1 REDLINE REVISION 2/11/04

MARYLAND DOT - STATE HIGHWAY ADMINISTRATION
Office of Traffic & Safety
TRAFFIC ENGINEERING DESIGN DIVISION

MD 190 AND WHITTIER BLVD/WINSTON DR

DRAWN BY: WJ NIES	F.A.P. NO.		TS NO. 3176 B	SHEET NO. 1 OF 2
CHECKED BY: RR ZACHERL	S.H.A. NO.			
SCALE: 1"= 20'	COUNTY:	MONTGOMERY	T.I.M.S. NO. F679	
DATE: 6-12-91	LOG MILE:	15019013.55

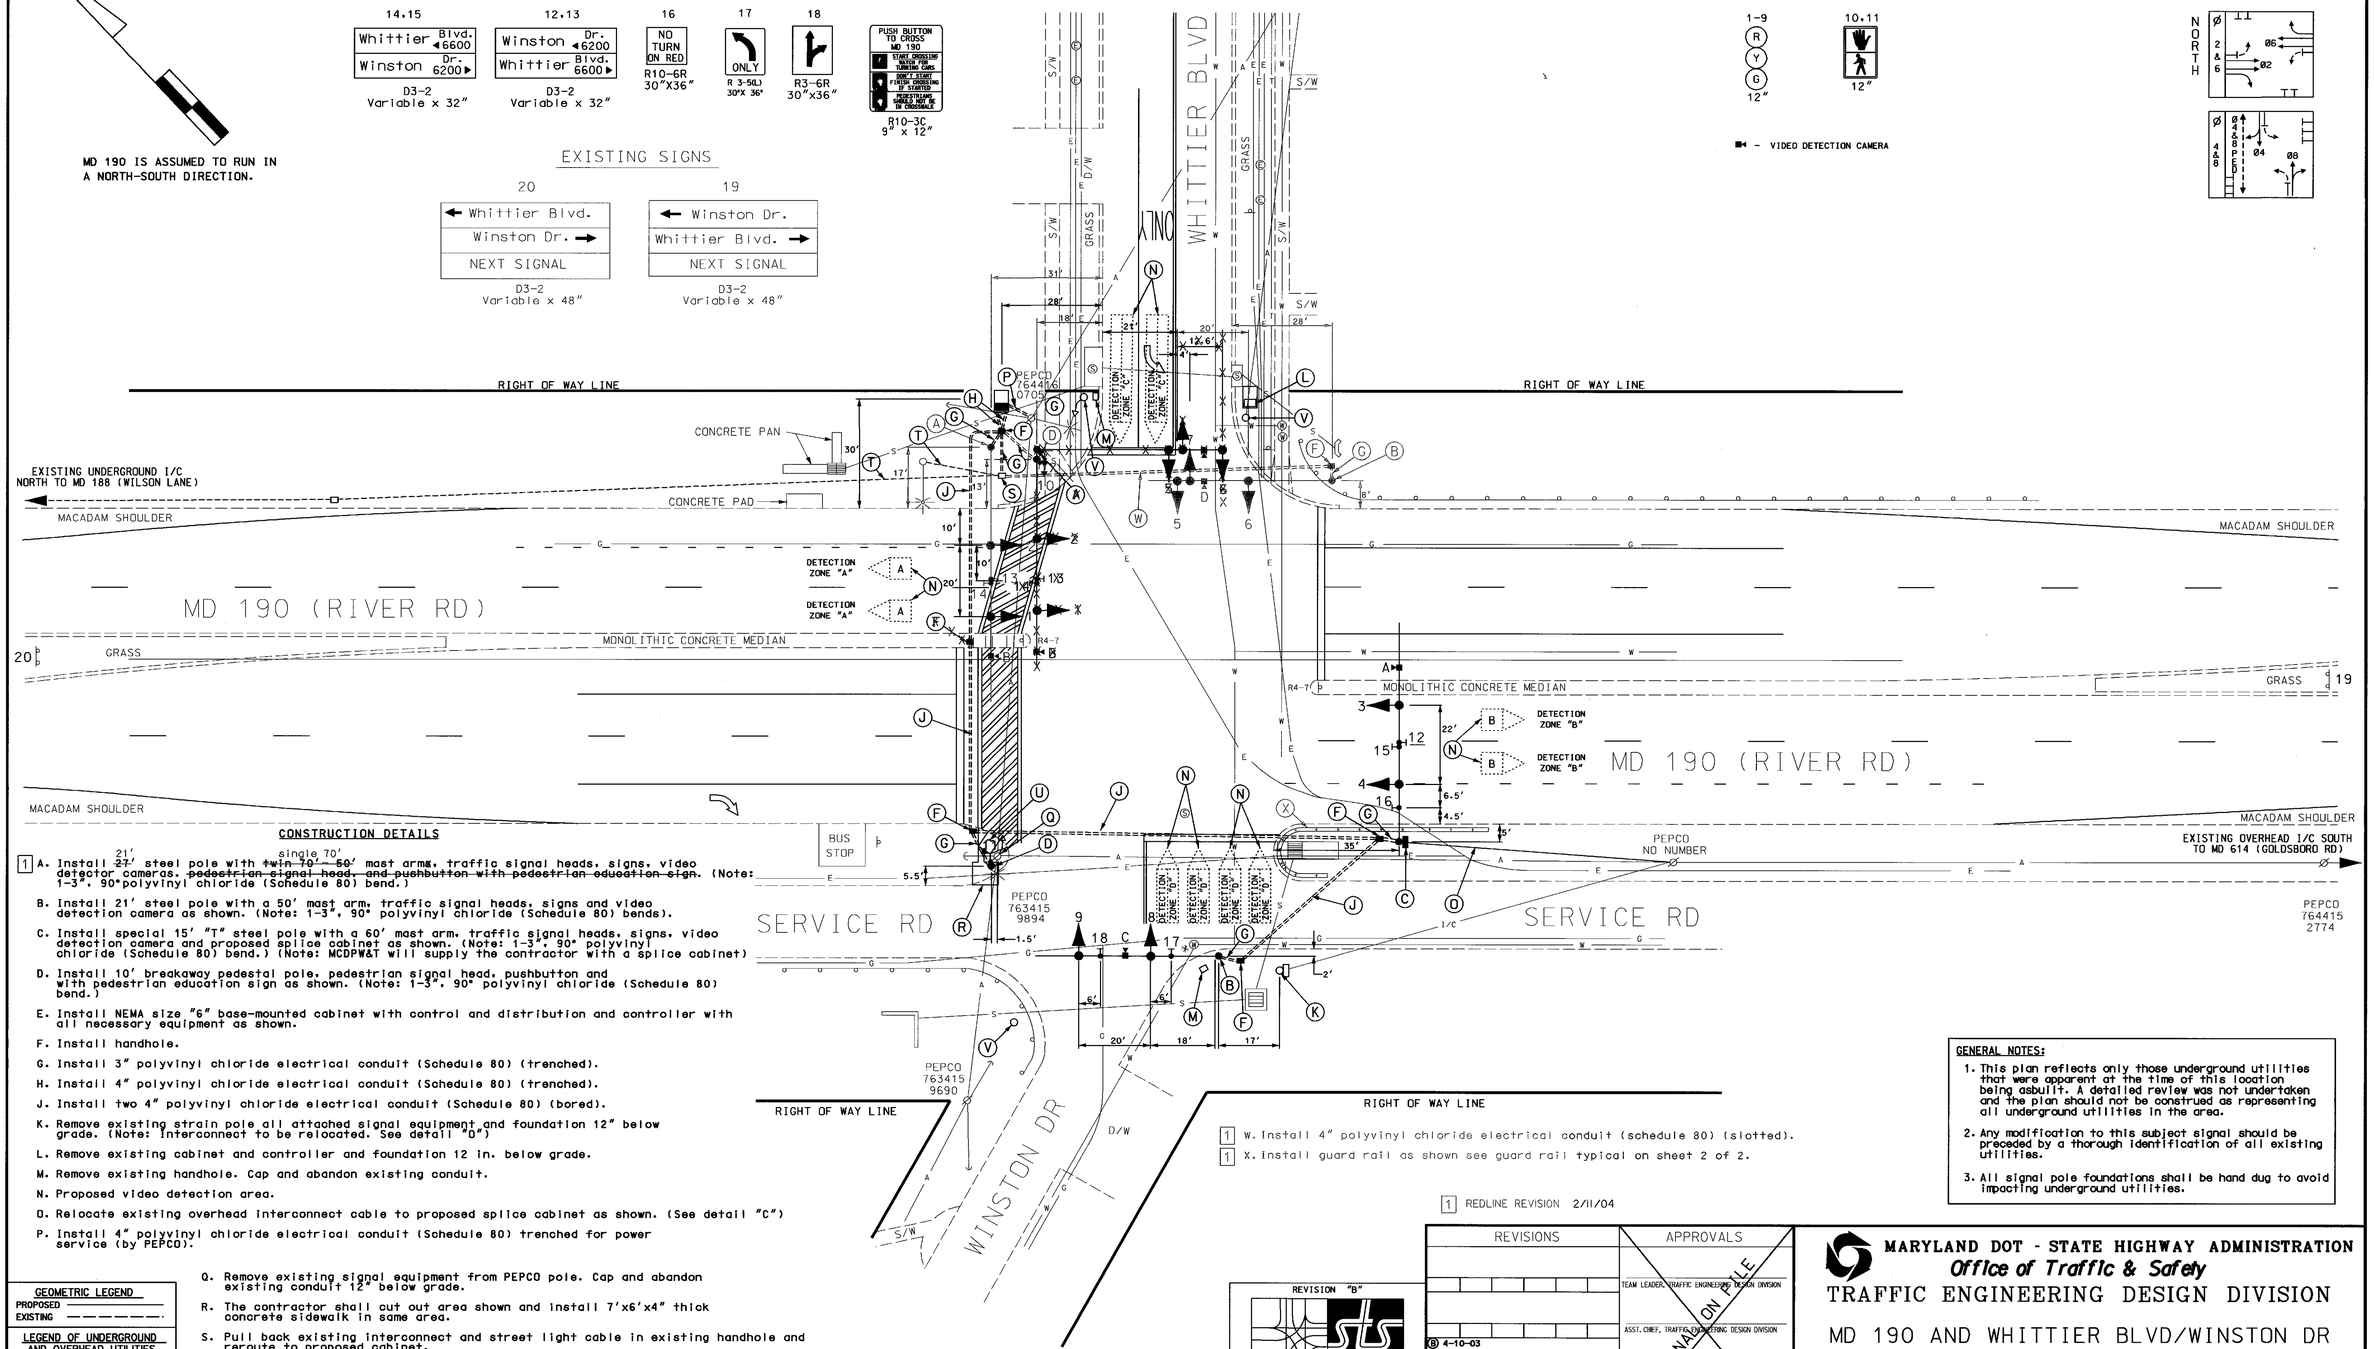
1 A. Install ~~27'~~ 21' steel pole with ~~twin 70' - 50'~~ single 70' mast arms, traffic signal heads, signs, video detector cameras. ~~pedestrian signal head, and pushbutton with pedestrian education sign.~~ (Note: 1-3", 90° polyvinyl chloride (Schedule 80) bend.)

1 W. Install 4" polyvinyl chloride electrical conduit (schedule 80) (slotted).

1 X. Install guard rail as shown see guard rail typical on sheet 2 of 2.
